MAC/PHY Delay Variability: Corner Cases and Solutions

Introduction

- OLT Control Multiplexor (Figure 77-13) →

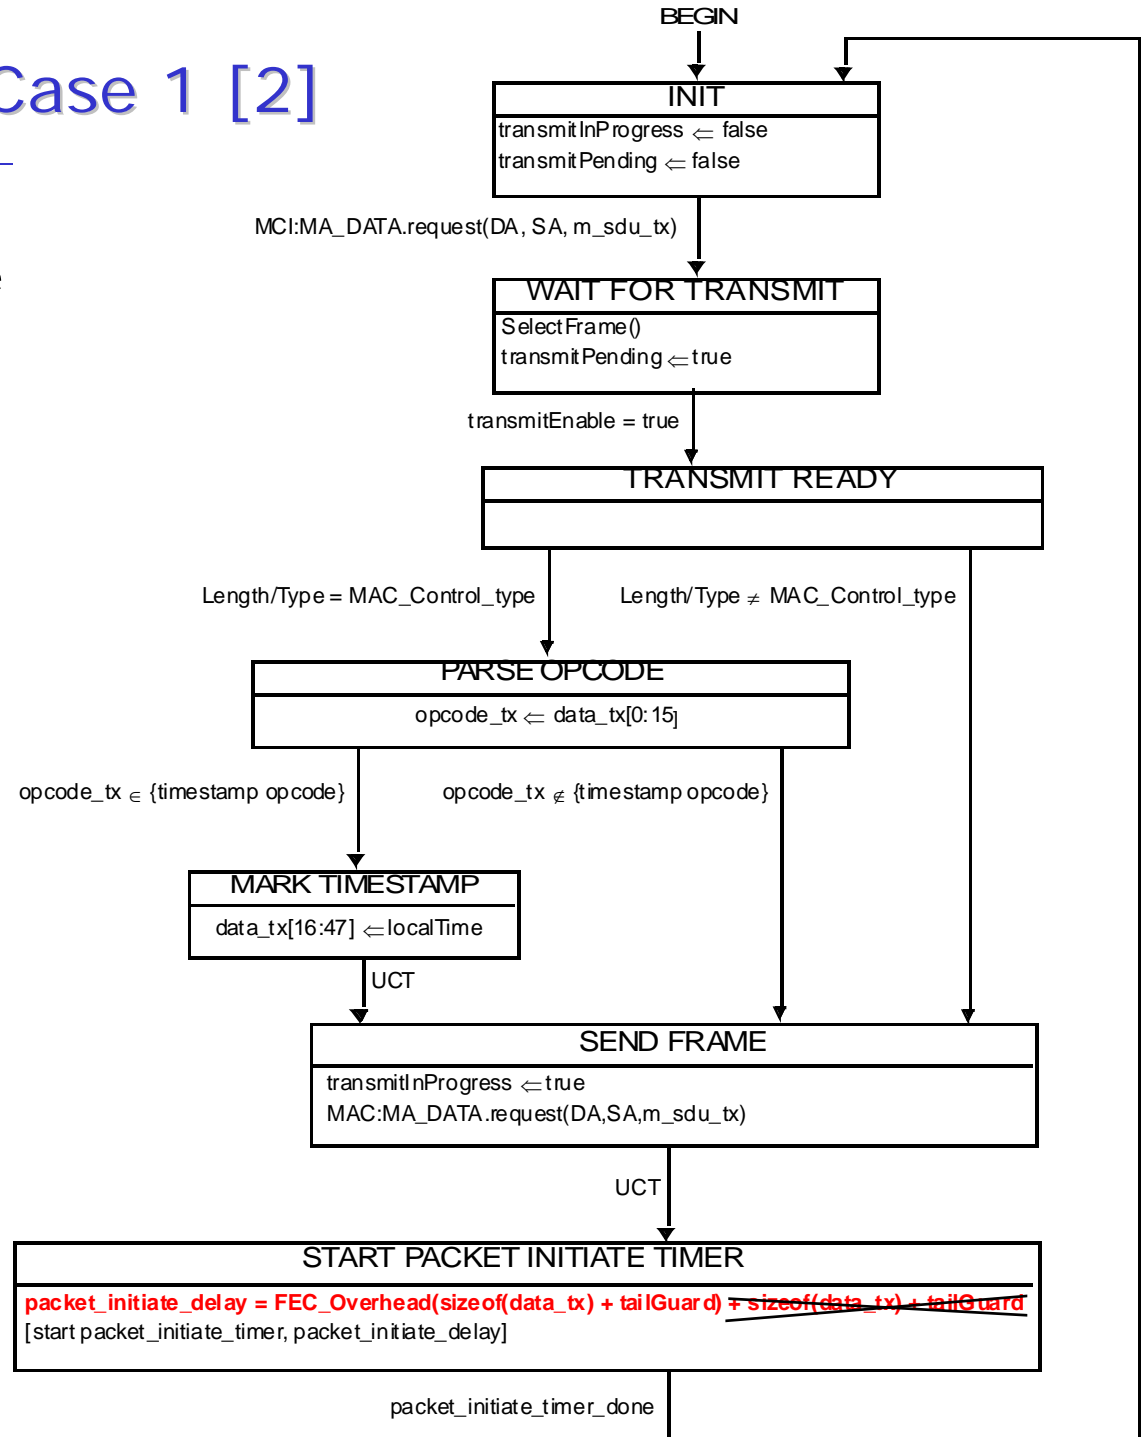
- In state START PACKET INITIATE TIMER, replace

$$\text{packet_initiate_delay} = \text{FEC_Overhead}(\text{sizeof}(\text{data_tx}) + \text{tailGuard}) + \text{sizeof}(\text{data_tx}) + \text{tailGuard}$$

with

$$\text{packet_initiate_delay} = \text{FEC_Overhead}(\text{sizeof}(\text{data_tx}) + \text{tailGuard})$$

- OLT Control Multiplexor (Figure 77-13) →

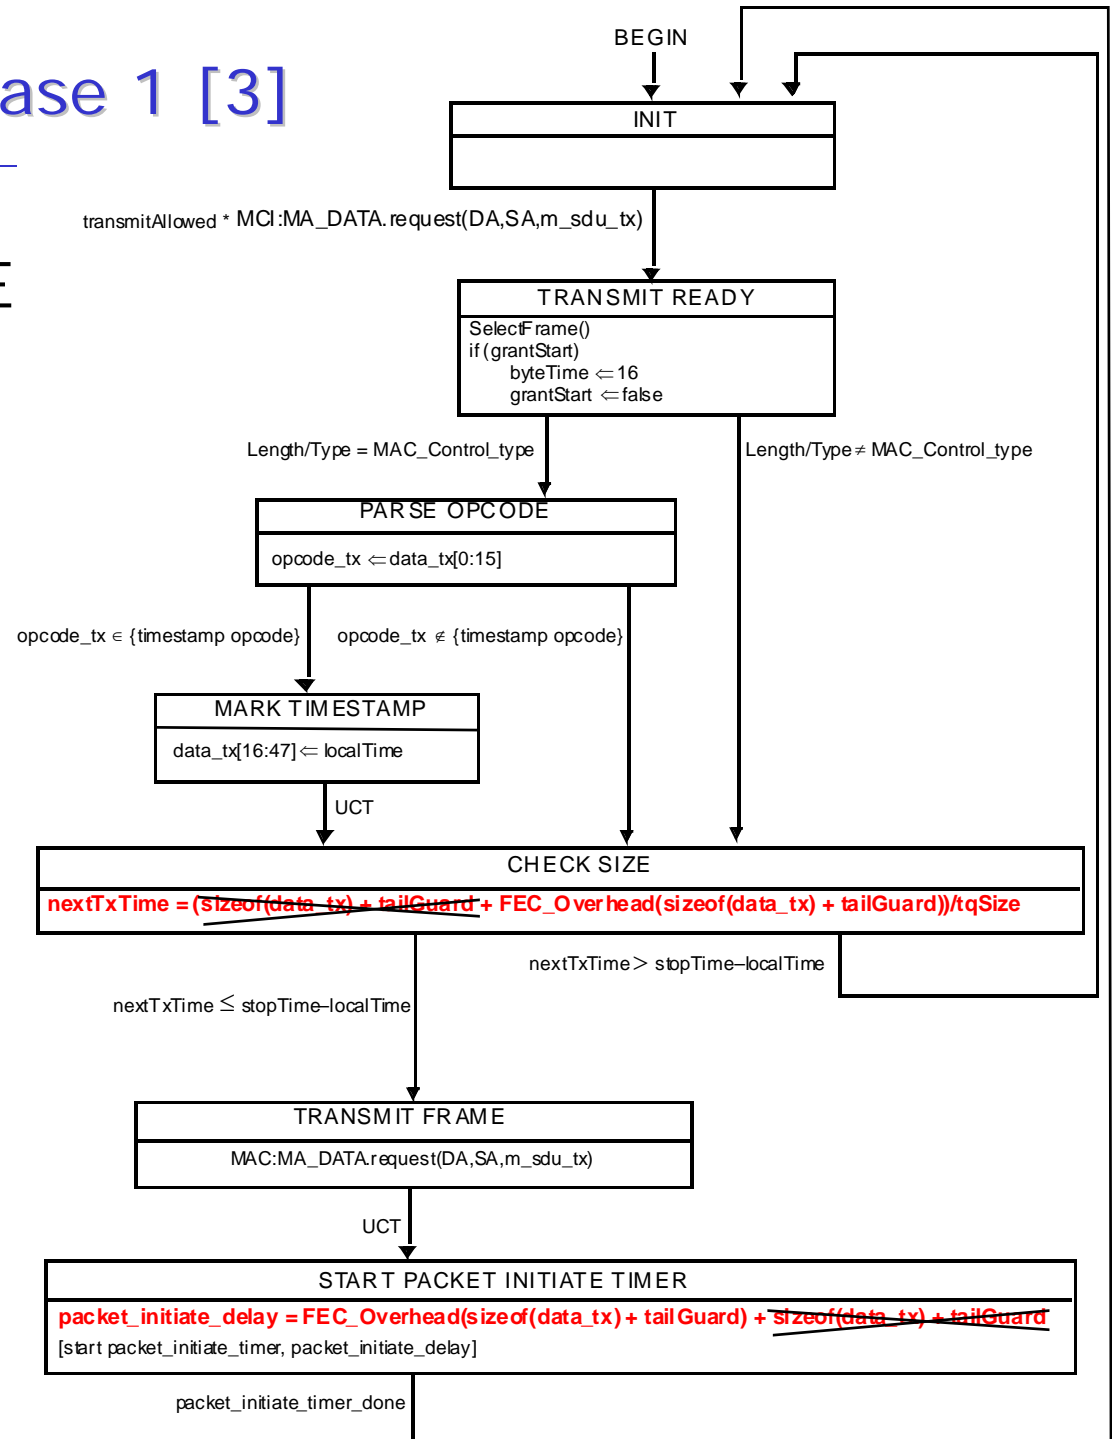
- In states CHECK SIZE and START PACKET INITIATE TIMER, delete

sizeof(data_tx) + tailGuard

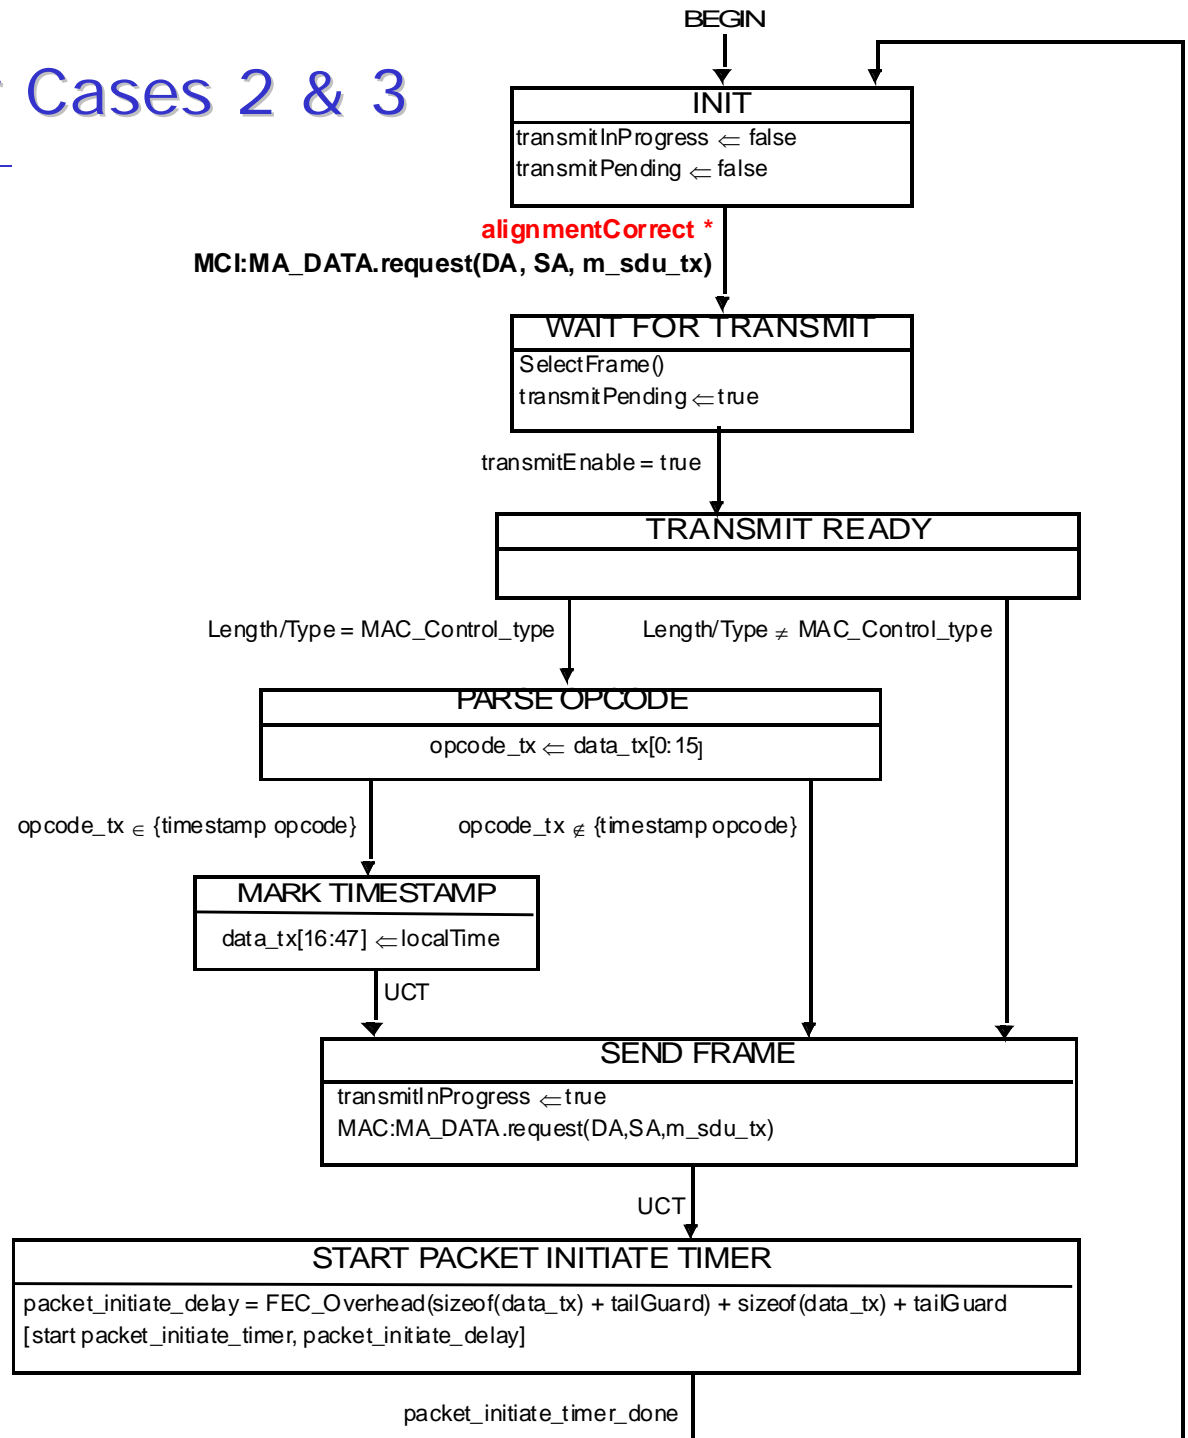
- Modify transition from INIT to WAIT TO TRANSMIT to allow frames through only
 - On column boundary and
 - During payload portion of FEC codeword.
- MAC Control frames that arrive during the parity portion will be delayed **before timestamping** until the parity part completes and column boundary is aligned.
- OLT Control Multiplexor (Figure 77-13) →

- ONU Control Multiplexor (Figure 77-14) →**

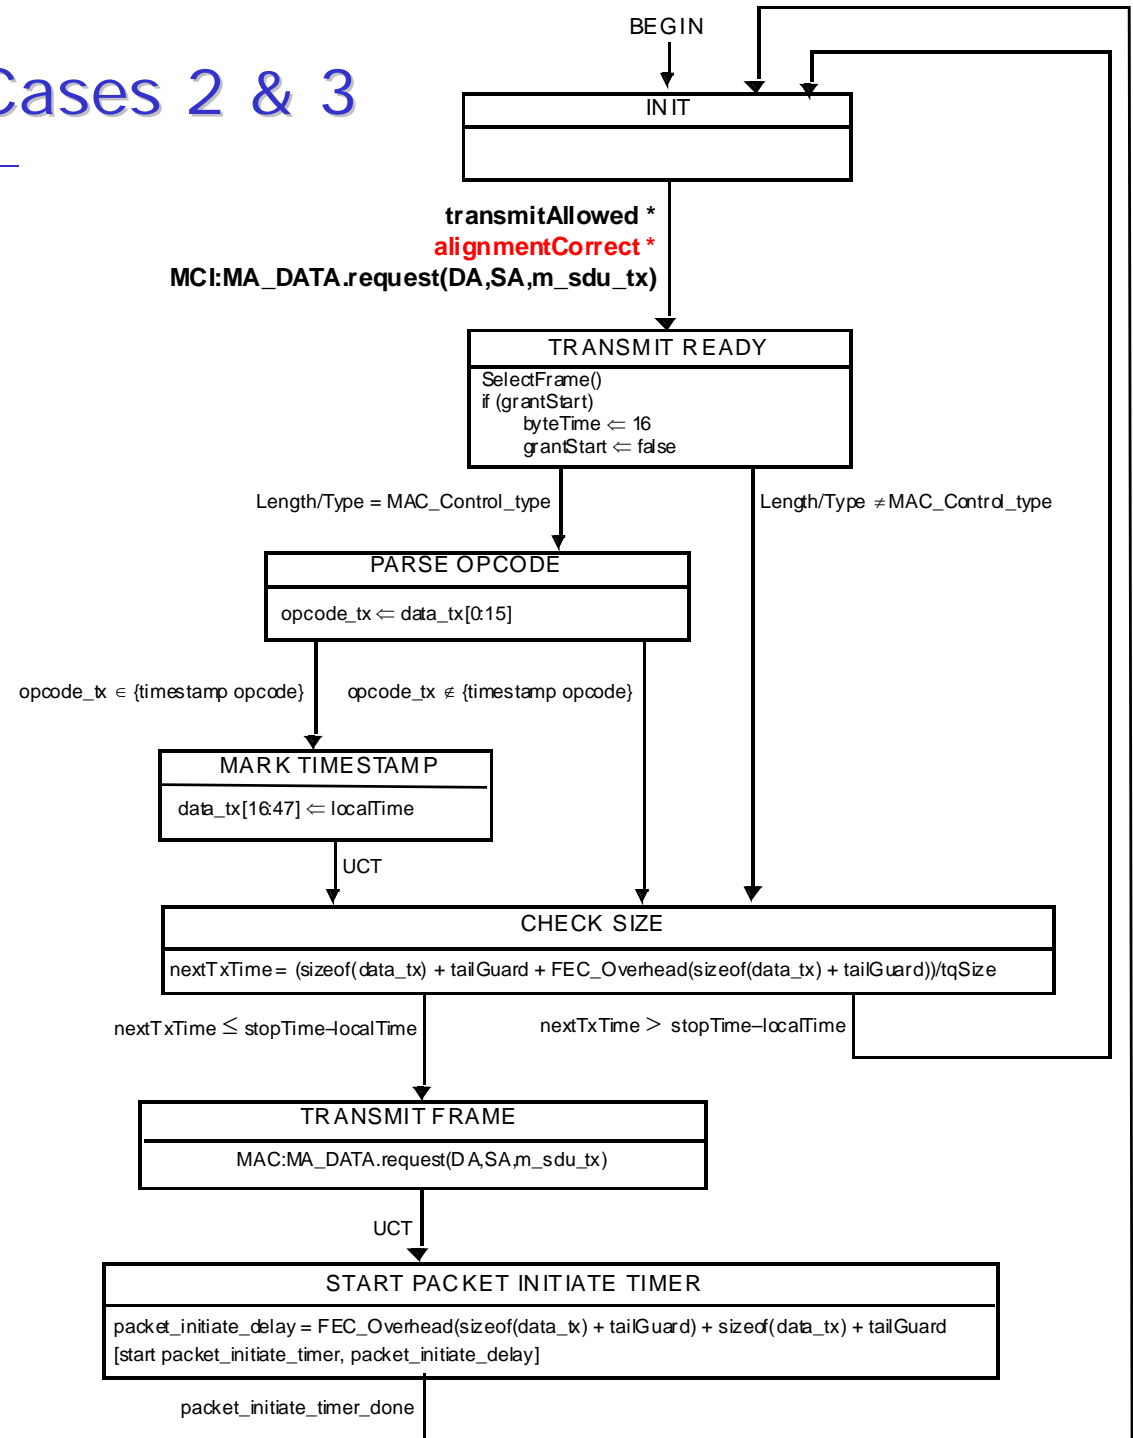
- Similar modification should be made to ONU Control Multiplexor.

- A new variable alignmentCorrect should be defined as follows:

At the OLT, this variable is an alias for the condition $\text{byteTime}[1:0] == 0 \text{ AND } \text{byteTime} < \text{FEC_PAYLOAD_SIZE}$.

At the ONU, this variable is an alias for the condition $\text{byteTime}[1:0] == 0 \text{ AND } (\text{byteTime} < \text{FEC_PAYLOAD_SIZE} \text{ OR } \text{grantStart})$.

This variable is set true on column boundaries (XGMII transfers) occurring during the payload part of an FEC codeword. It is reset to false with the next increment of byteTime.
